STATE OF MAINE
DEPARTMENT OF TRANSPORTATION
16 STATE HOUSE STATION
AUGUSTA, MAINE 04333-0016

March 3, 2023
Subject: Frank J. Wood Bridge Replacement
State WIN: 022603.00
Location: **Brunswick & Topsham**
Amendment No. 3

FJ Wood Bridge WIN 022603.00
Interpretive Panels 36" Wide x 24" High
Locations (4) - Topsham

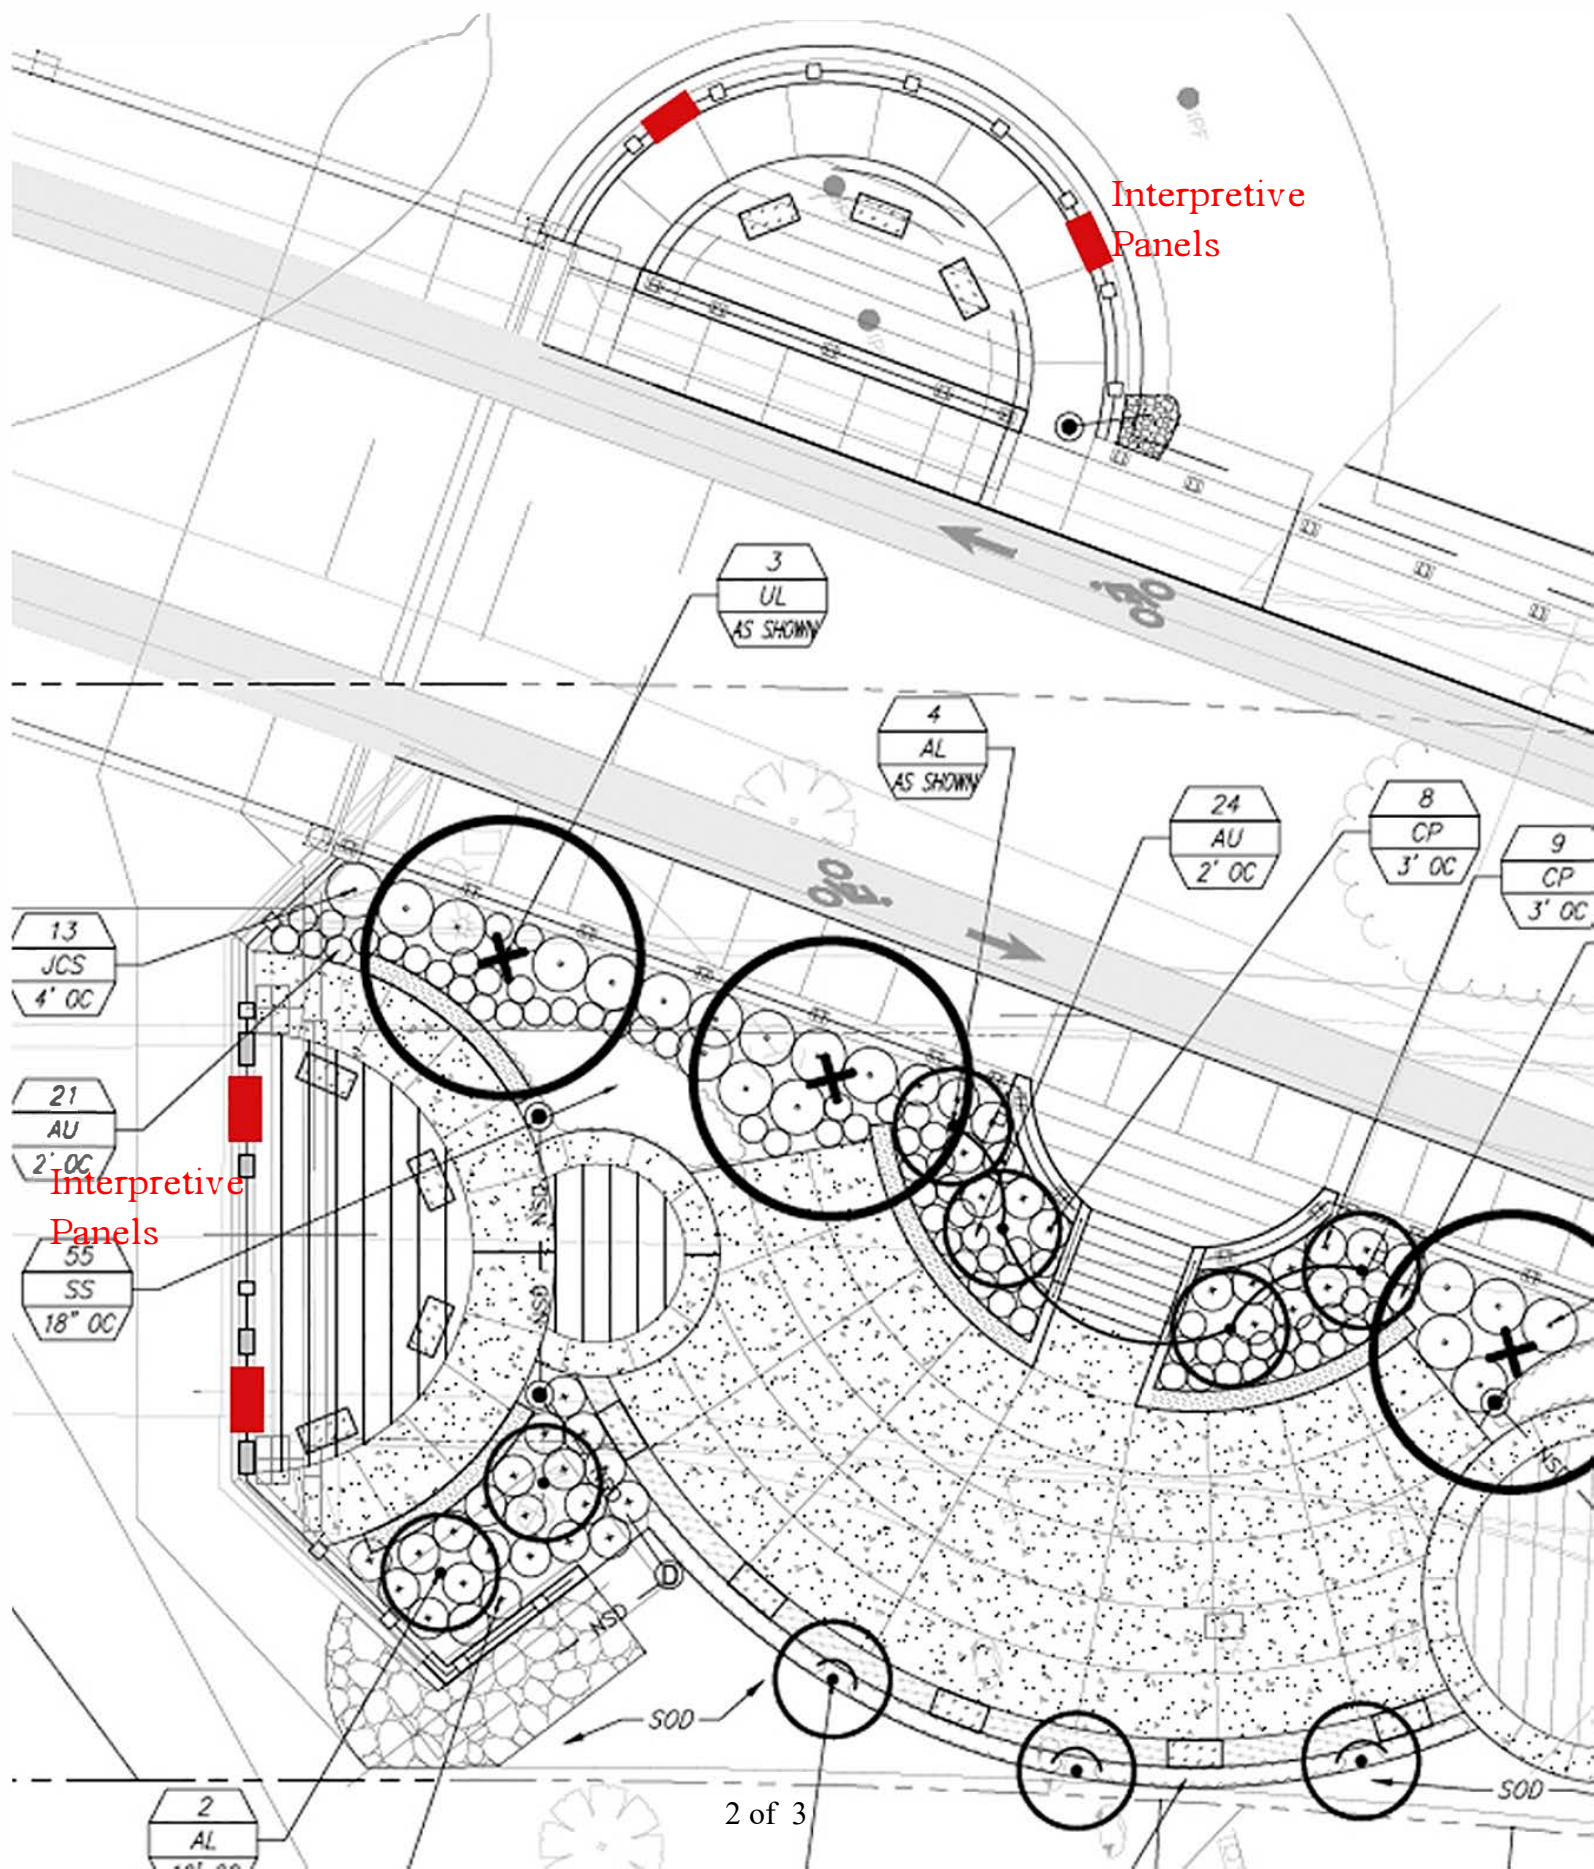
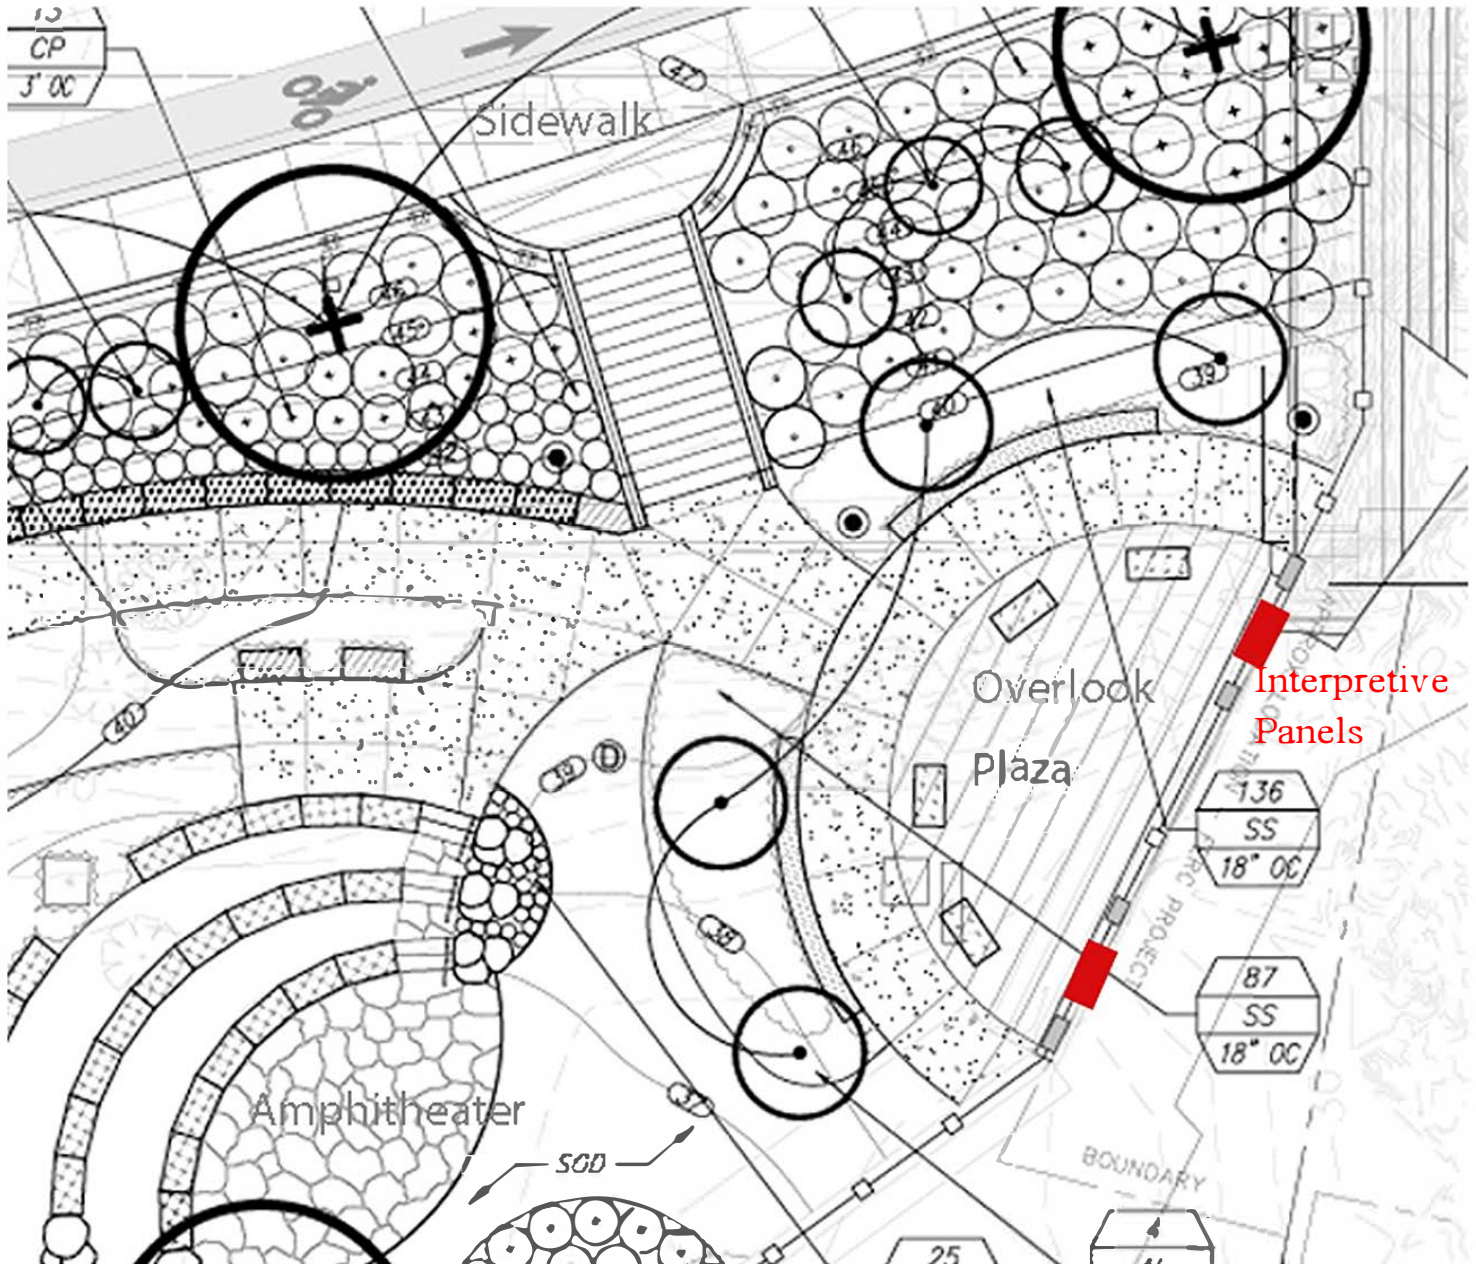
Question: Can the Department please provide locations and a detail showing the mounting brackets for the Specail Signing item 645.51?

Response: See above changes to the bid documents.

Description. Special Signing shall consist of furnishing all materials and equipment necessary for the fabrication, finishing, and installation of the interpretive panel mounting brackets, as well as the installation of the six (6) MaineDOT supplied 36" Wide x 24" high interpretive panels, in accordance with these specifications, as shown on the Plans, and as directed by the Resident.

SHEET NUMBER
20A
OF 163

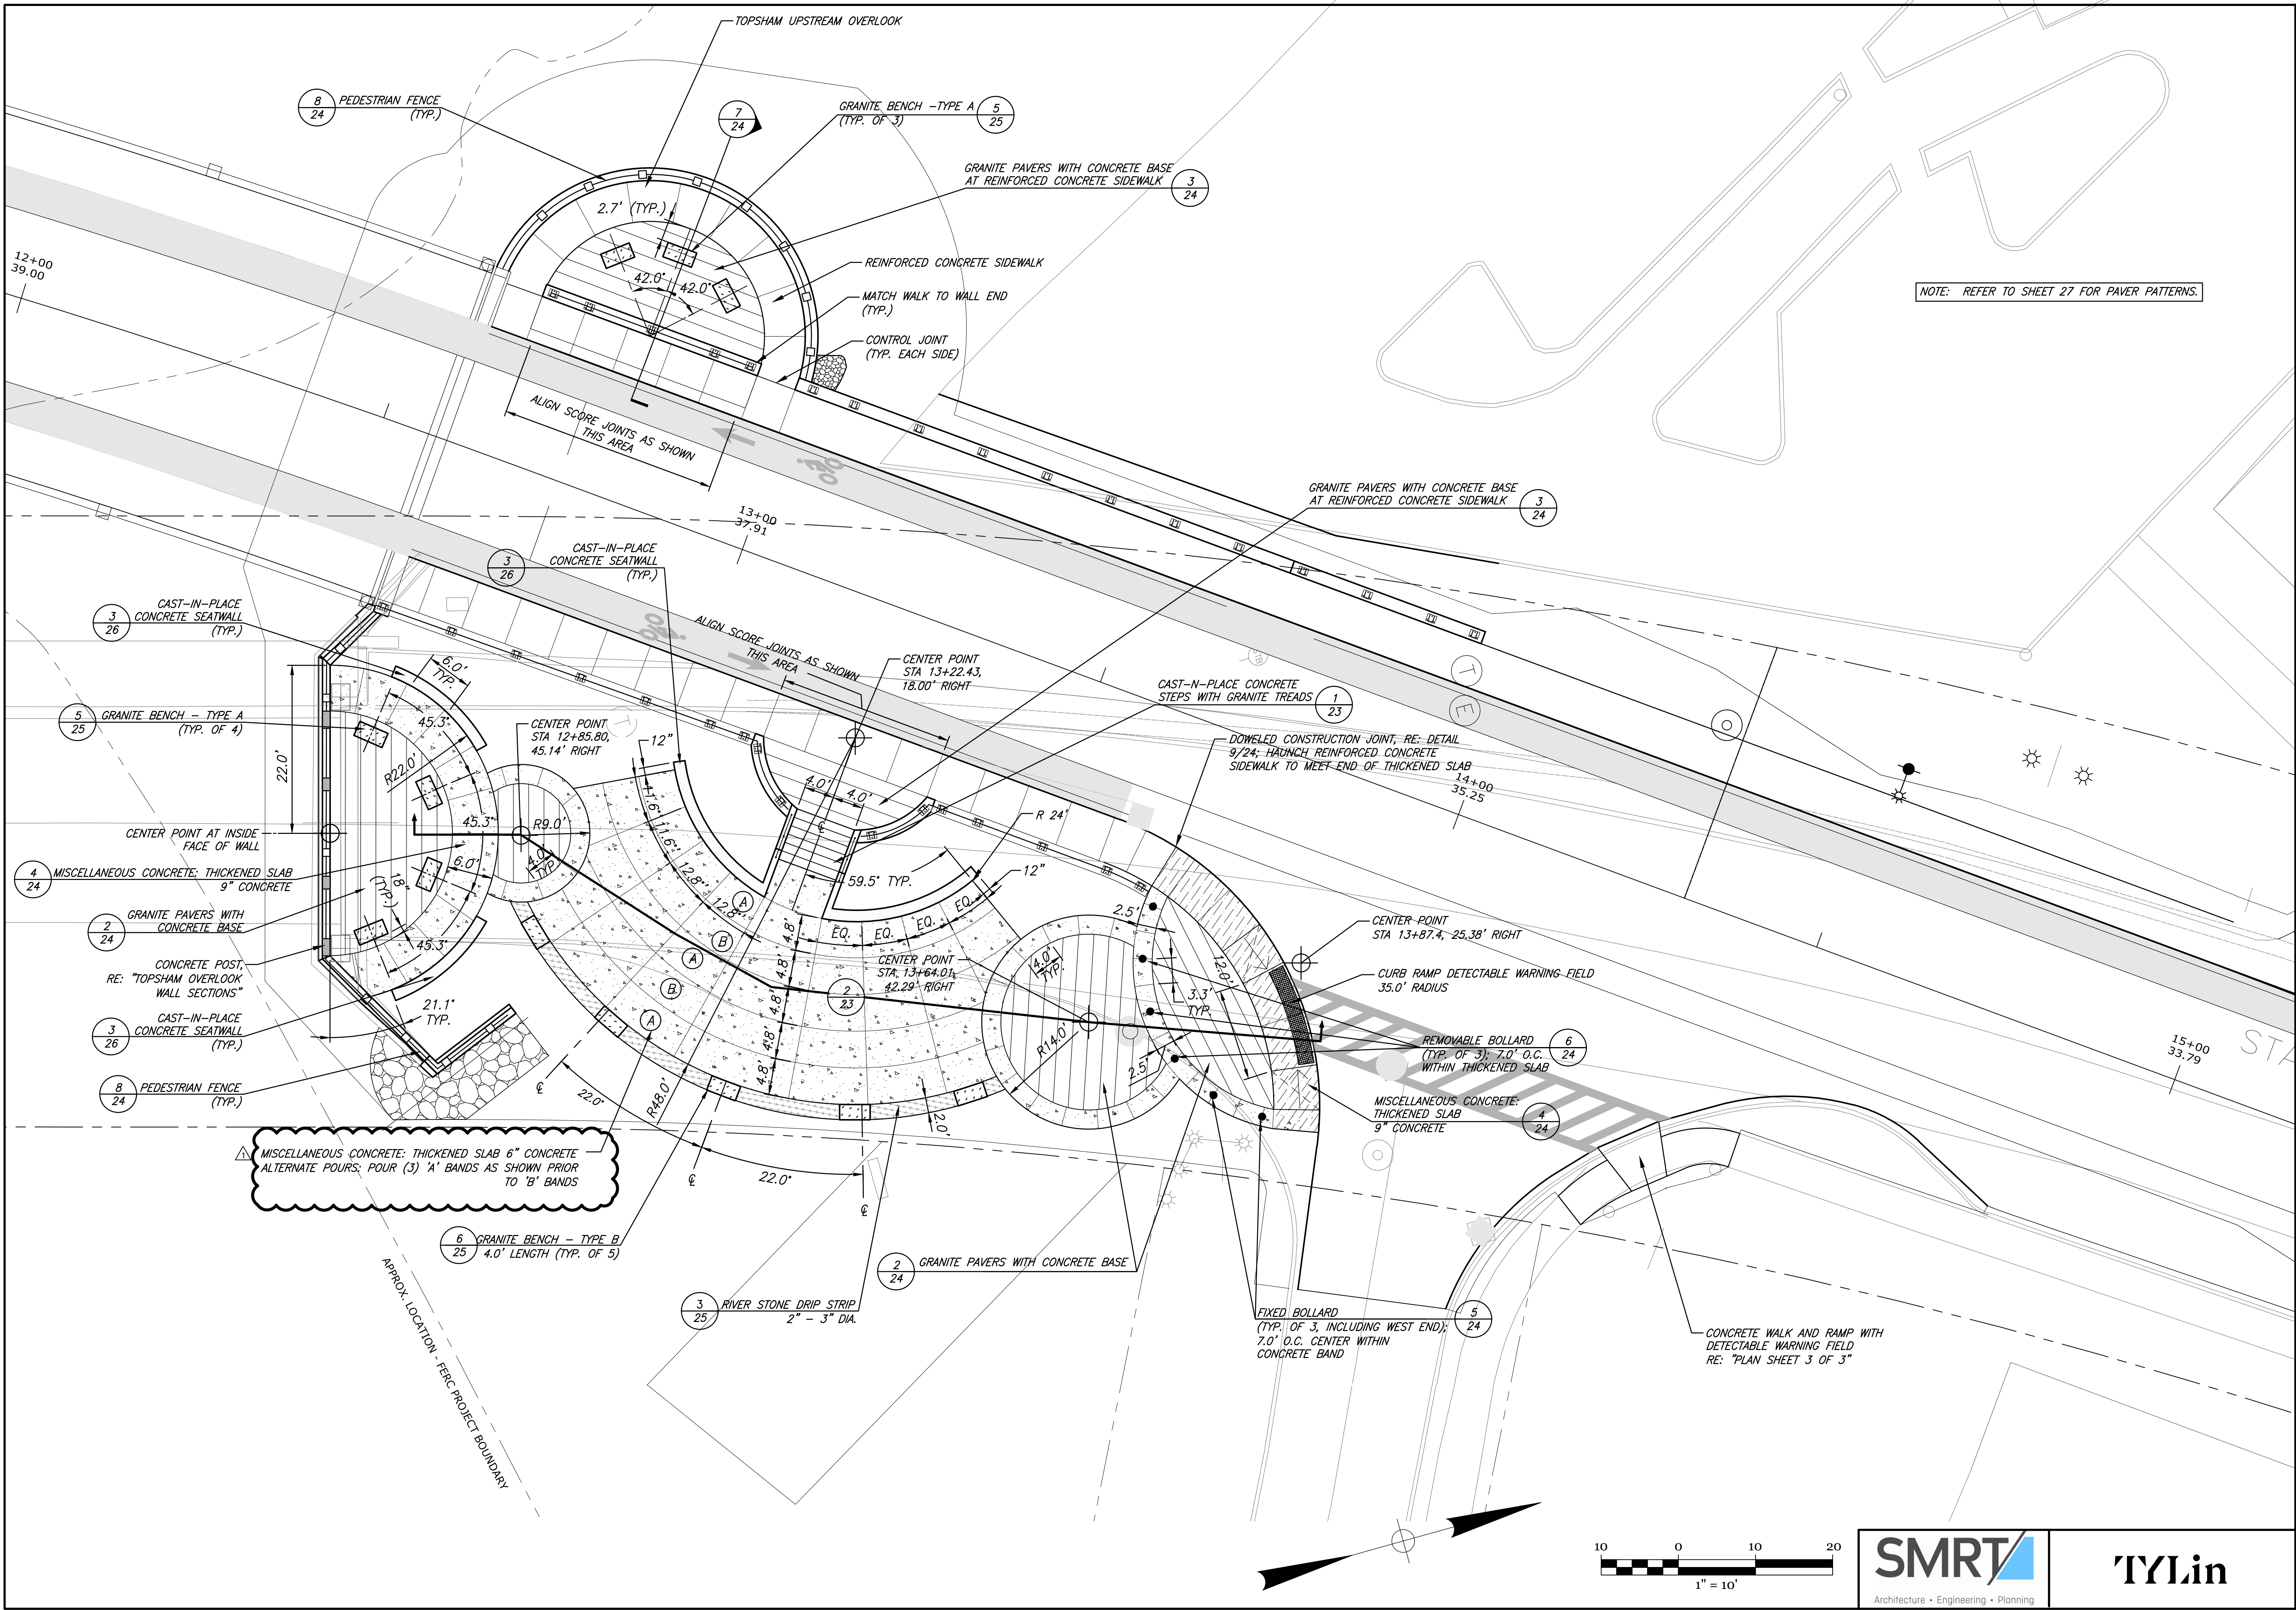
Question: Sheet number 20 depicts an area on the East side of US Route 201/Route 24B that states "Reinforced Concrete Sidewalk Alternate Pours: Pour (3) 'A' Bands As Shown Prior To 'B' Bands". Section 2 through that area that is shown on Sheet 23 appears to label this same area as "Miscellaneous Concrete: Thickened Slab 6" Concrete". Please clarify if this area is to be paid for under Item 608.08 Reinforced Concrete Sidewalk or Item 502.2356 Miscellaneous Concrete: Thickened Slab. If paid for under item 608.08, should the quantity for item 502.2356 be revised?

REMOVE Sheet 20, TOPSHAM SITE DESIGN/AMENITIES LAYOUT & MATERIALS PLAN, 1 sheet dated 12/17/21 and **REPLACE** with attached Sheet 20A, TOPSHAM SITE DESIGN/AMENITIES LAYOUT & MATERIALS PLAN, 1 sheet dated 3/23.

Response: See above changes to the bid documents. Estimated Quantities listed are correct.
